TAG AXLE ATTACHMENT SCREWS - REPLACEMENT 9700 (B13R)

DESCRIPTION

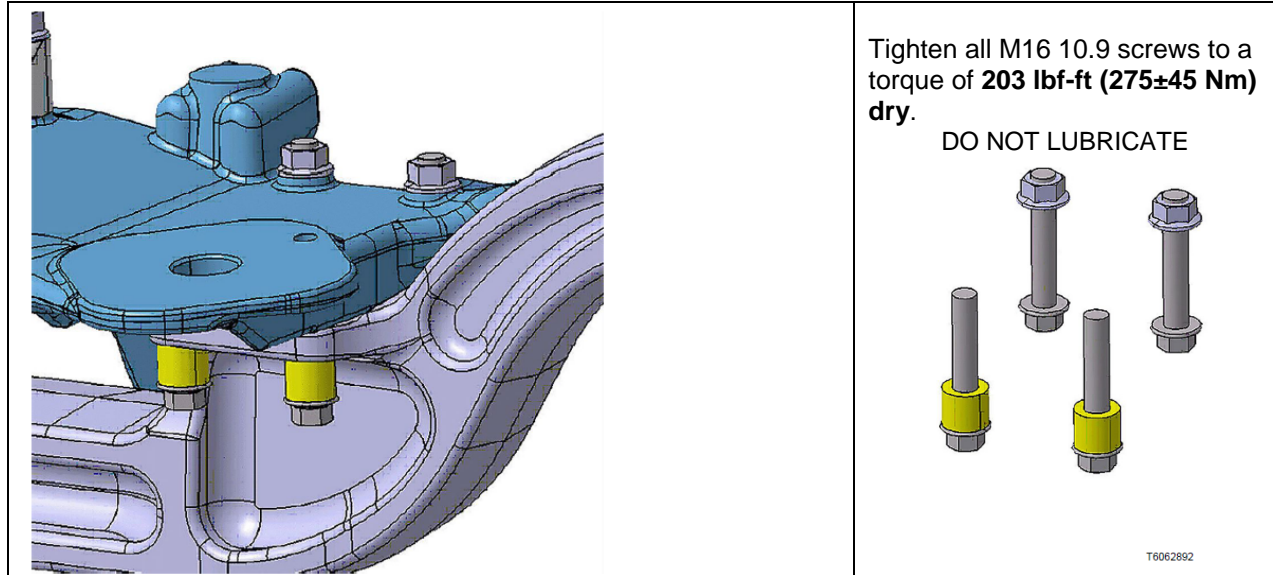
On the vehicles mentioned above, the flange screws for the anchorage of tag axle air bellows on the trailing axle do not meet our requirements. All vehicles concerned shall be rectified at the next service occasion but within the stipulated time period.

1. While proceeding with one screw at a time, replace screws and add the spacer sleeves as show, on both sides of TAG axle. Use four (4) new M16 screws of 10.9 grade (0.9 grade needs a higher tightening torque: **203 lbf-ft (275±45 Nm dry)**).
